**From:** Mcconnell, DAVE P <dave.p.mcconnell@lmco.com>  
**Sent:** Thursday, January 11, 2018 9:21 AM  
**To:** Grant Robinson  
**Cc:** Thomas Jacobson; Mrazik, Philip; Daryl Dixon; Aaron Scally  
**Subject:** S-76D TR Boot Fairing Repair

Case Number: C0078633  
Customer: Thai Aviation Services Limited  
Aircraft S/N: 761XXX  
Aircraft Model: S-76D  
ATA: 64  
Part Number: 76101-06025-041  
Case Subject: S76D TR Boot Fairing Damage Repair Greater Than CMM Limits

TR Boot Fairing

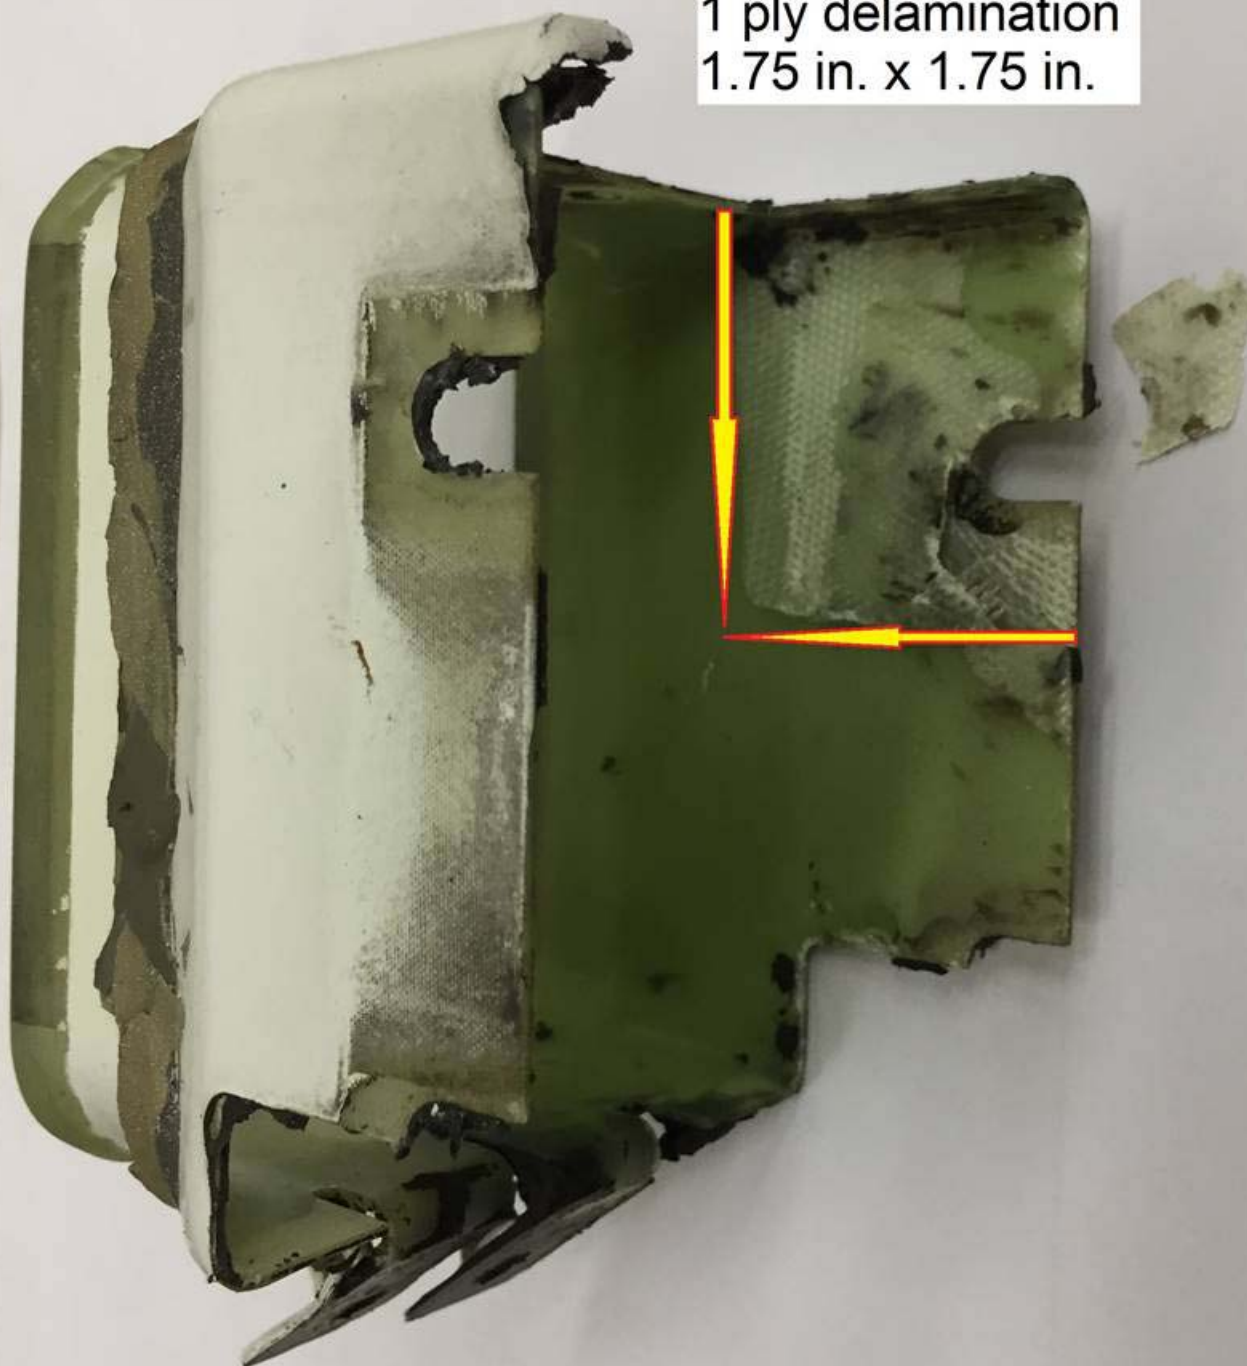
TAS reports two recent events of P/N 76101-06025-041 tail rotor boot fairing damage incurred while trying to separate the boot fairing from the Proseal in which it was bedded.

Damage in both cases was virtually identical and resulted in the delamination of a single ply (0.010 inches deep) over an area 1.75 inches by 1.75 inches square.

CMM 65-25-00 T-Rev 65-03 Table 202 Item 9 lists Boot Fairing edge bond separation maximum as 0.125 in. deep maximum.

TAS have a well-equipped and staffed composite shop. They propose to repair both boot fairings by vacuum bagging a single ply fiberglass and EA956 over the damaged area using standard CMM procedures.

In order to avoid a prolonged AOG situation TAS request SA approval to repair the damage as described above using existing CMM procedures. EoM

1 ply delamination  
1.75 in. x 1.75 in.

Sikorsky Blades engineering has reviewed the case details and concurs with the proposed repair procedure.
